**RE: Revised Subdivision Application – Baltimore Ridge
23 Baker Road & 25 Baker Road
CHA Project No. 092529**

CHA, on behalf of the applicant/owner, is pleased to submit the enclosed revisions to the Subdivision Application related to the above referenced property.

REVISIONS		FINAL PLAN RESUBDIVISION OF LOT Nos. 3 & 4 INTO LOT No. 3A BALTIMORE RIDGE AMENDED PART OF LOT No. 24 VILLAGE OF MARCELLUS ONONDAGA COUNTY, NEW YORK		
		DATE: JANUARY 14, 2025	SCALE: 1" = 20'	SHEET No.
		FILE No.: 2286.126		F.B. No. 1467

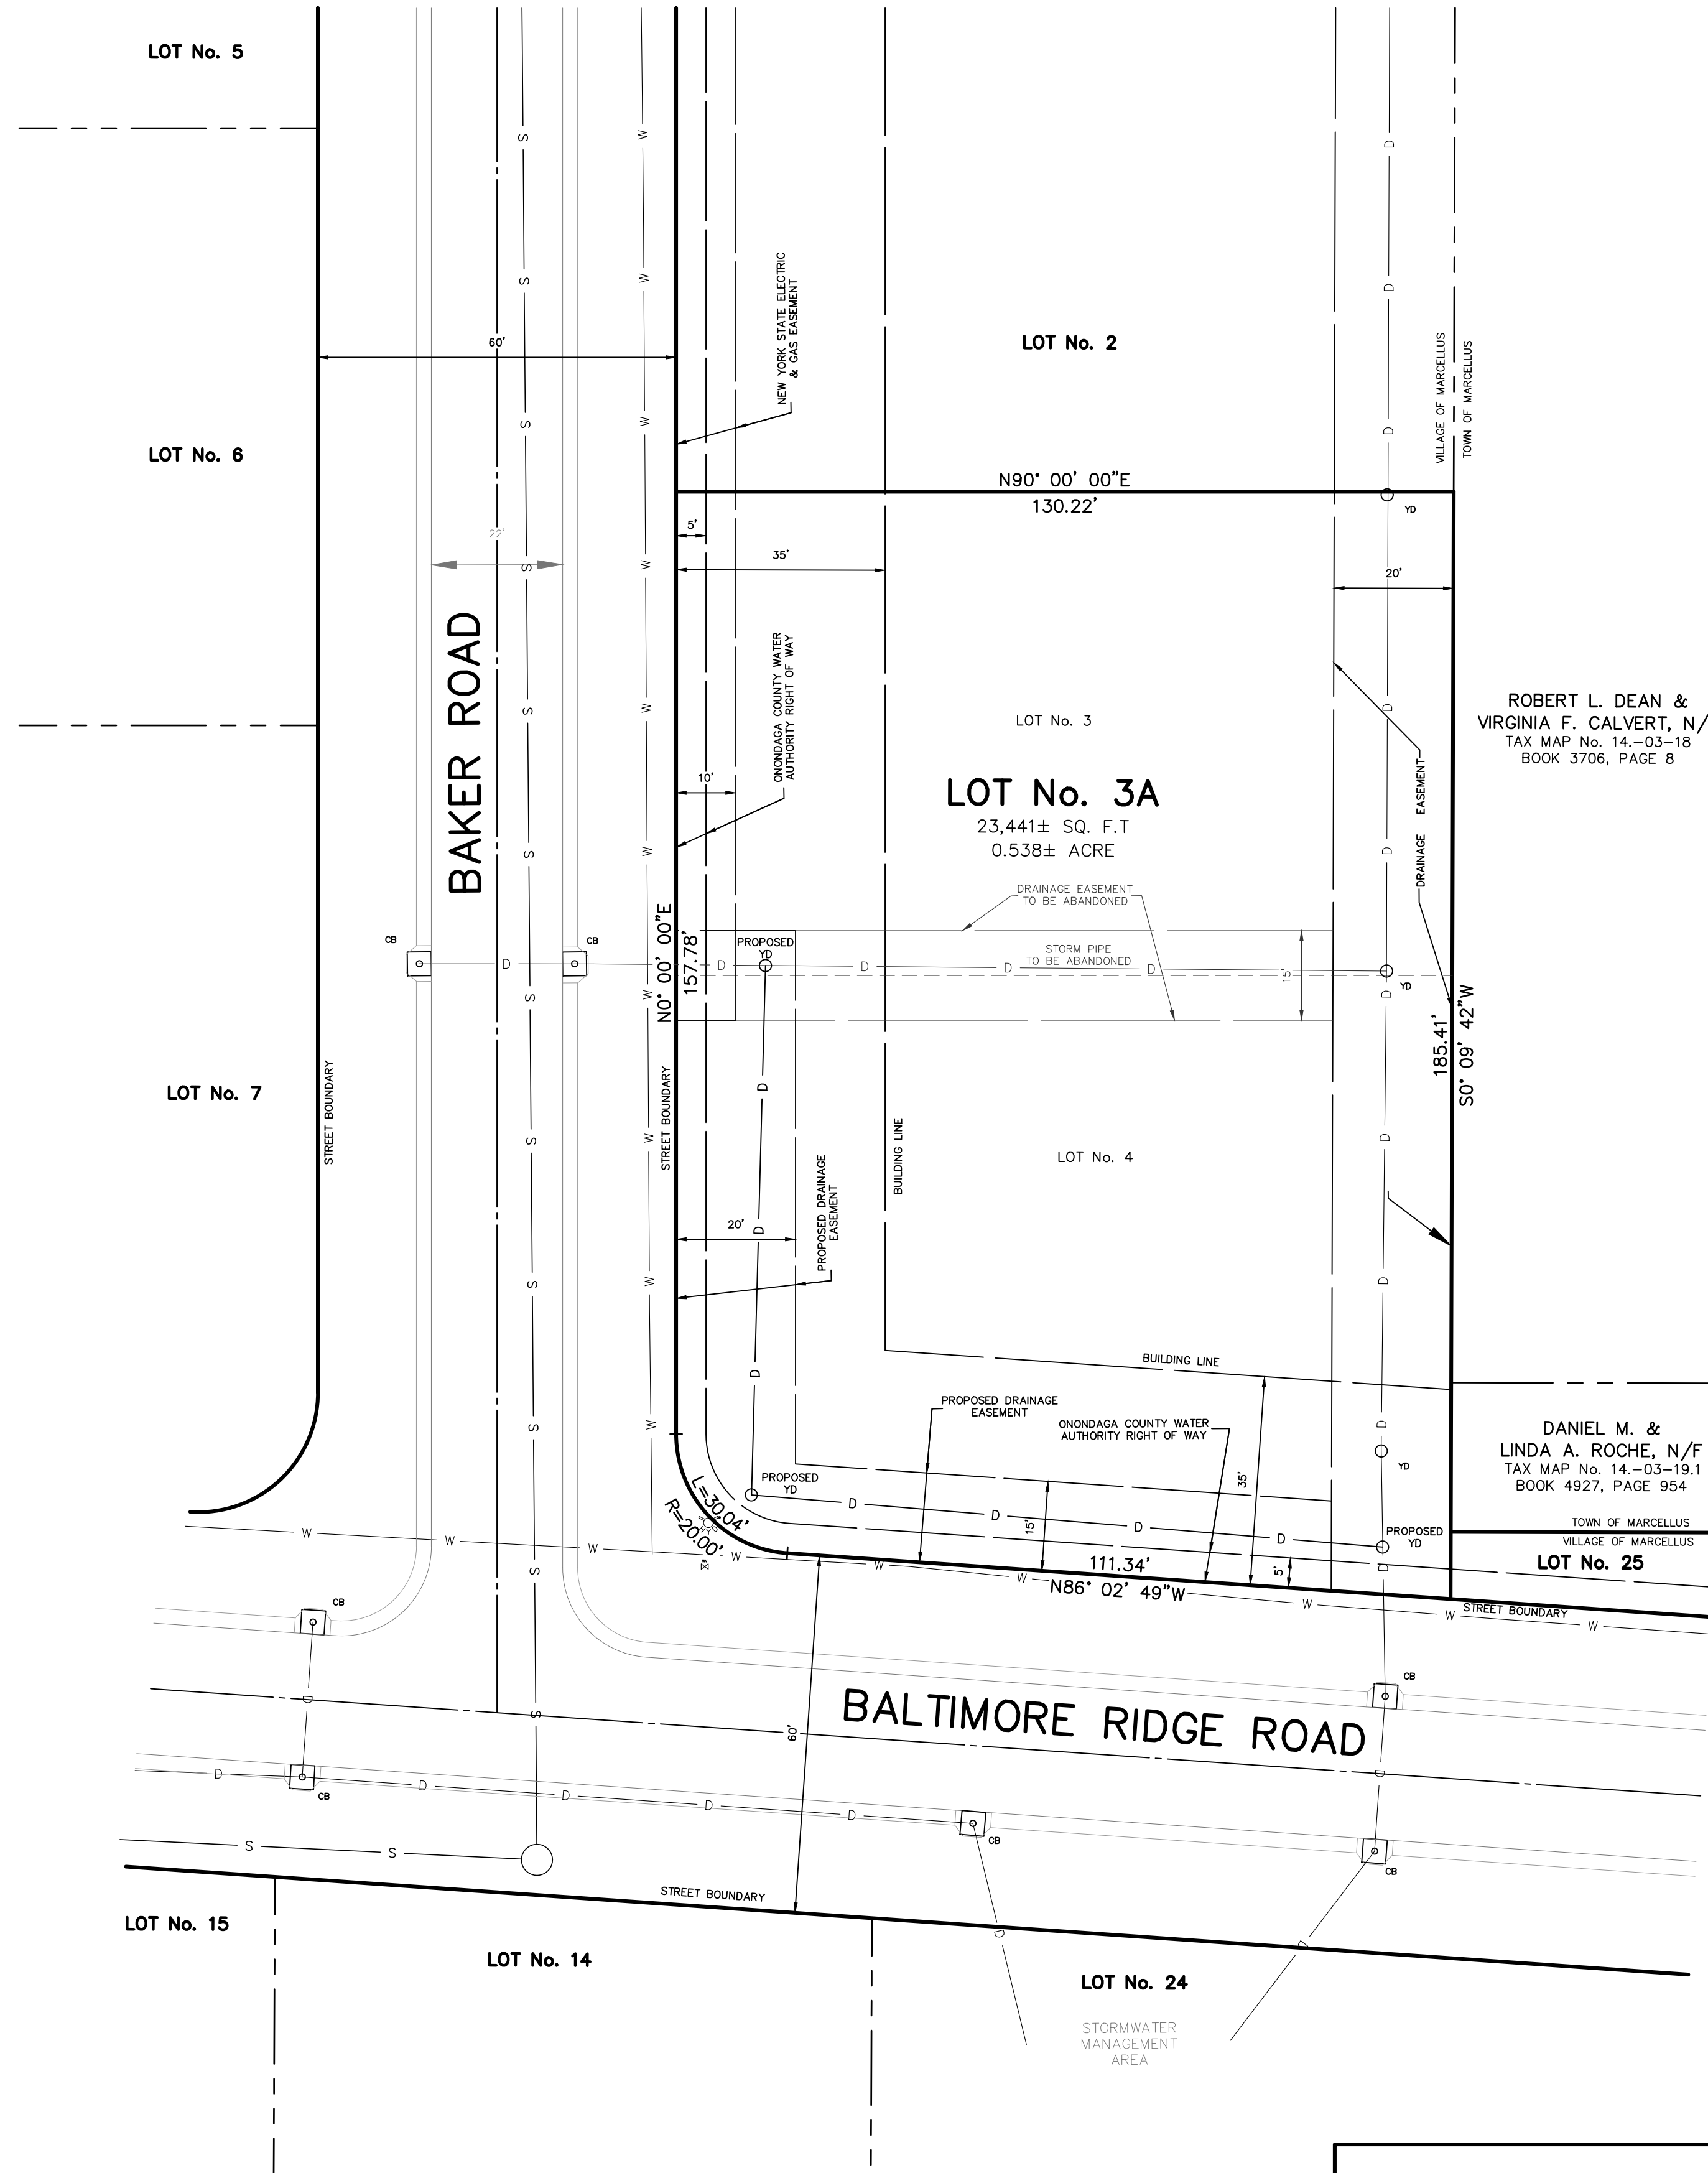
The map has been revised based on comments from the Village Engineer to now include a 20ft proposed drainage easement along Baker Road and a 15ft drainage easement along Baltimore Ridge Road.
